City of Portland, Maine – Building or Use Permit Application 389 Congress Street, 04101, Tel: (207) 874-8703, FAX: 874-8716

BUILDING PERMIT REPORT

DATE: 27 February 1999 ADDRESS: Verrill ST. Lot #13 CBL 299-D-034
 REASON FOR PERMIT: To Construct a one (1) Family dwelling attached garage
 BUILDING OWNER: David Chase
 CONTRACTOR: Keith Alling
 PERMIT APPLICANT: ↑
 USE GROUP R-3 BOCA 1996 CONSTRUCTION TYPE 5-B

**CITY OF PORTLAND, ME
BOCA 1996 Plan Review Record
One and Two Family Dwelling**

Lot 13

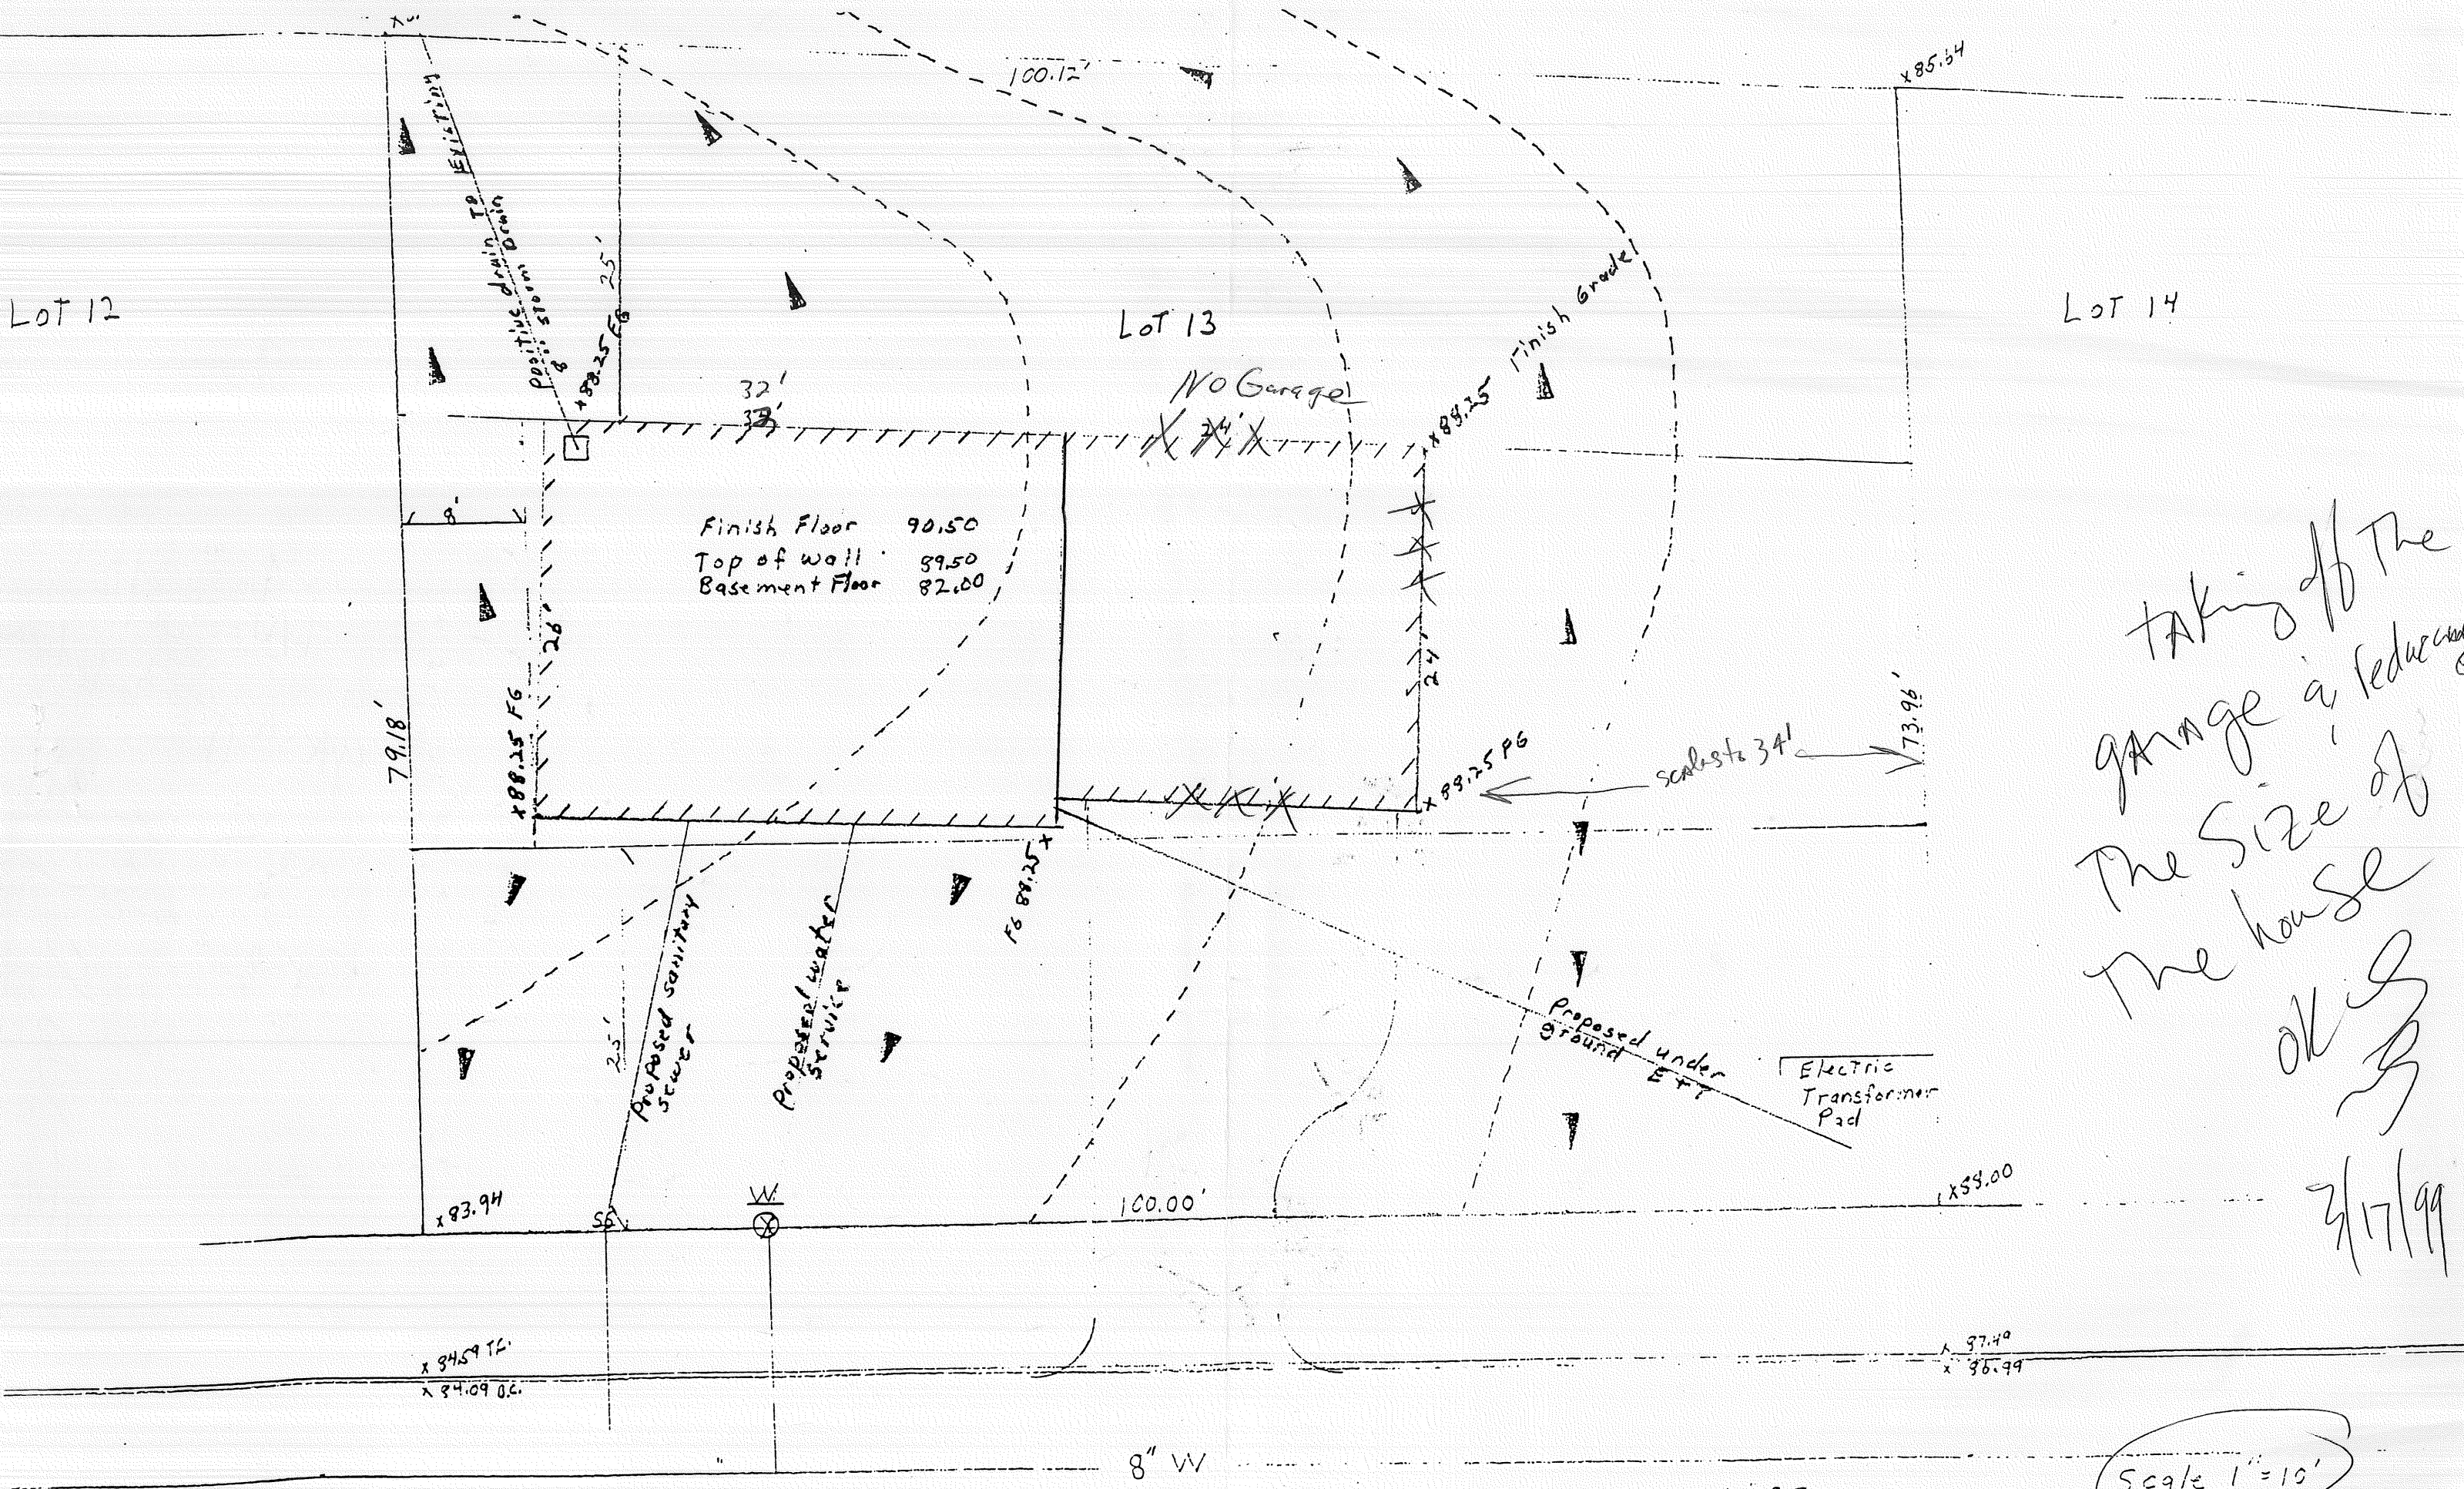
taking off the
 garage is reducing
 the size of
 the house
 ok
 3/17/99
